# **FREDERICK COUNTY PLANNING COMMISSION**

**TITLE:** Horan Residential Cluster Preliminary Plan

**FILE NUMBER:** S-1154, AP 13190 (#13215 APFO)

**REQUEST:** Residential Cluster Preliminary Plan Approval

Graphic #2

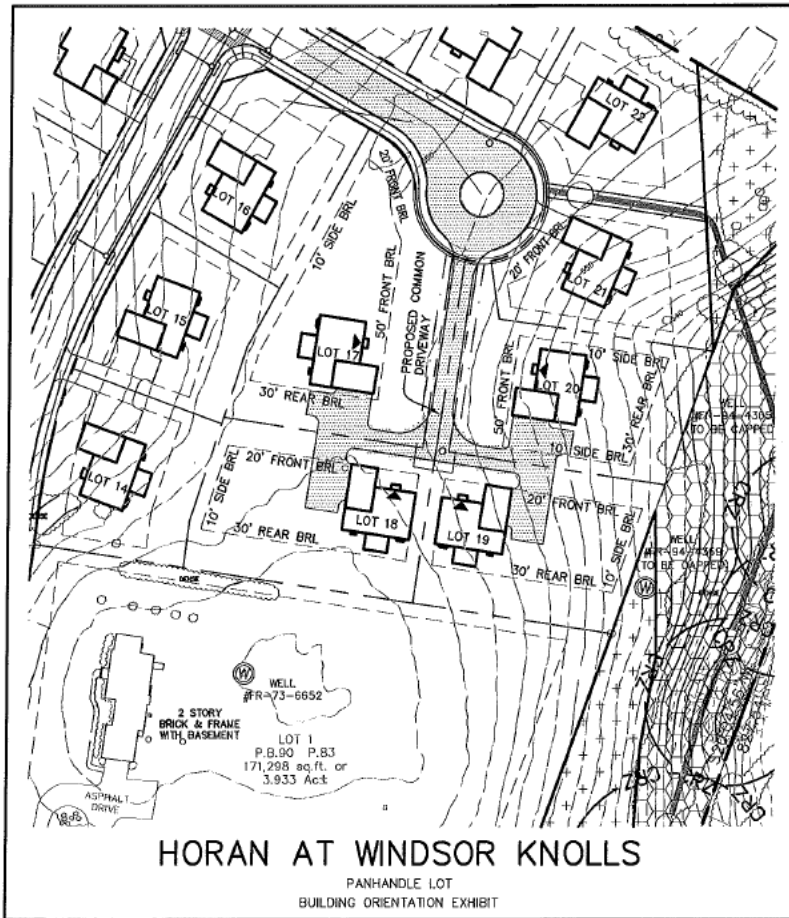
The Subdivision Regulations (1-16-219.c.3) do not allow more than 3 panhandle lots. Lots 18-20 are panhandle lots. Lot 17 is not a panhandle although it will be accessed from the proposed common drive, and face the proposed panhandle common driveway.

The three panhandle lots will take access off of Horan Court via a common driveway serving lots 18-20, a tentative lot and driveway layout is included in the plan set on page 2 of 3, as well as shown in Graphic #2 below. The design below carefully considers the placement of the four houses, building restriction lines, and the use of a common driveway to preclude the possibility of front to back stacking of the proposed homes. In addition, side entry garages provide a better design and more attractive house frontage.

Located on the highest portion of ground within the Horan tract is the existing 3 acre life estate of David C. Horan. The life estate creates a small segment of ground that can sewer into Windsor Knolls subdivision but cannot be efficiently served by the extension of a public road. There is insufficient width in a north south direction between the life estate and the property line to build another cul-de-sac off of Windmor Drive. Furthermore, limitations on gravity sewer prohibit the placement of the lots further to the east. The Applicant has agreed that all purchasers of the panhandle lots are to be notified of the responsibilities of maintaining the panhandle area and common driveway.

Staff supports the utilization of the common drive with panhandles for Lots 18-20.

PANHANDLE LOT  
BUILDING ORIENTATION EXHIBIT

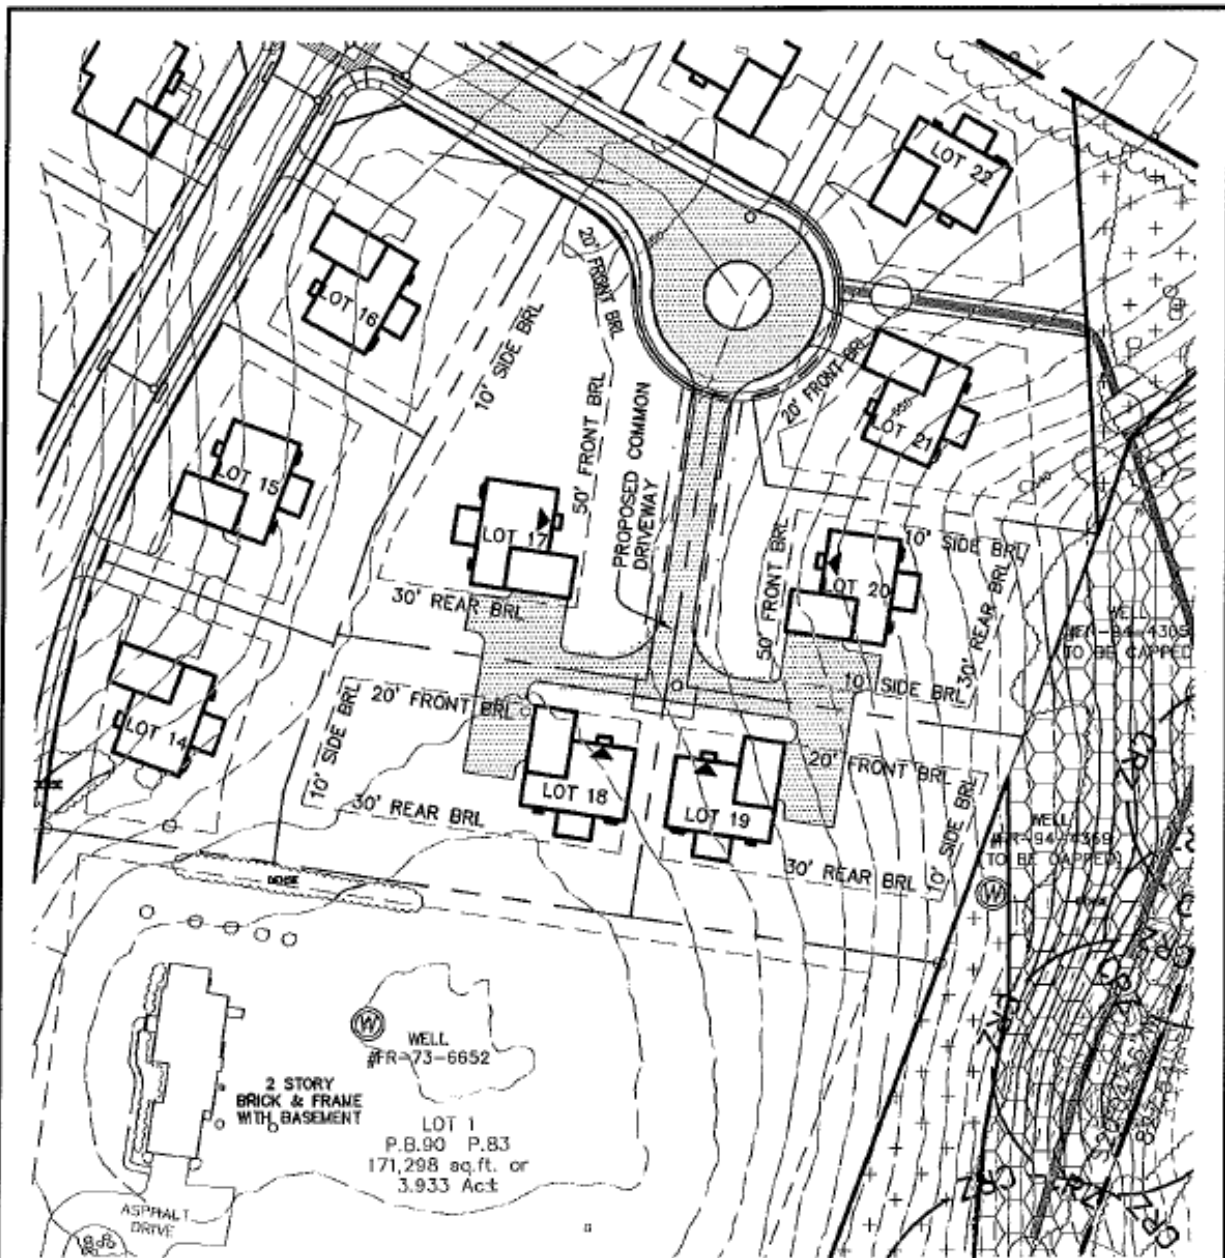
Per section 1-16-219(C)(2) of the Subdivision Regulations, Planning Commission modification approval of three panhandle lots is requested. Lot 17 is technically not a panhandle but will be accessed from, and face the proposed panhandle common driveway. Several unique spatial relationships within the property justify the approval of these panhandles. Horan at Windsor Knolls is a Residential Cluster Subdivision that achieves the creation of lots smaller than the standard R-1 40,000sf minimum lot size with the balance as common open space. This subdivision is to be a continuation of the neighborhood created in the adjacent Windsor Knolls subdivision.

Horan at Windsor Knolls is to be developed on public sanitary sewer and water. The need to provide a lot design that can sewer by gravity back towards and into the existing Windsor Knolls utilities results in a lot design that is sited on the higher ground and falls within the natural drainage basin. Located on the highest ground of the Horan subdivision is the existing 3 acre life estate of Daniel C. Horan which contains an existing large house and established evergreen landscaping. This estate was recorded over a year ago and its location at the top of the hill and its relationship to the original Horan property boundaries establish the location of the proposed public streets. The life estate creates a small segment of ground that can sewer into the Windsor Knolls subdivision but cannot be efficiently served by the extension of a public road. Insufficient width exists in a north south direction between the life estate and the property line to build another cul-de-sac off of Winmoor Drive. Furthermore, limitations on gravity sewer prohibit the placement of the lots further to the east. This natural topographic restriction prohibits opening up the space between lots 17 -20 to permit the extension and placement of the Horan Court cul-de-sac bulb in the area proposed as the common drive. Even if sufficient space were to exist the additional impervious blacktop and future public maintenance necessary for either a new or extended cul-de-sac is not justifiable based on environmental impacts or from the taxpayers fiscal responsibility.

As shown on the attached sketch careful placement of the proposed houses, building restriction lines and the use of a common driveway is proposed to preclude the possibility of front to back stacking of the proposed homes. As shown lots 17 & 20 will have a uniform front building restriction line parallel to the common driveway which allows lots 18 & 19 to face the public cul-de-sac. In addition, the side entry garages provide both design excellence and an aesthetic house frontage. Lastly, it is our understanding based upon feedback we have gotten from the builder, NVR, their customers like panhandle lots when available.
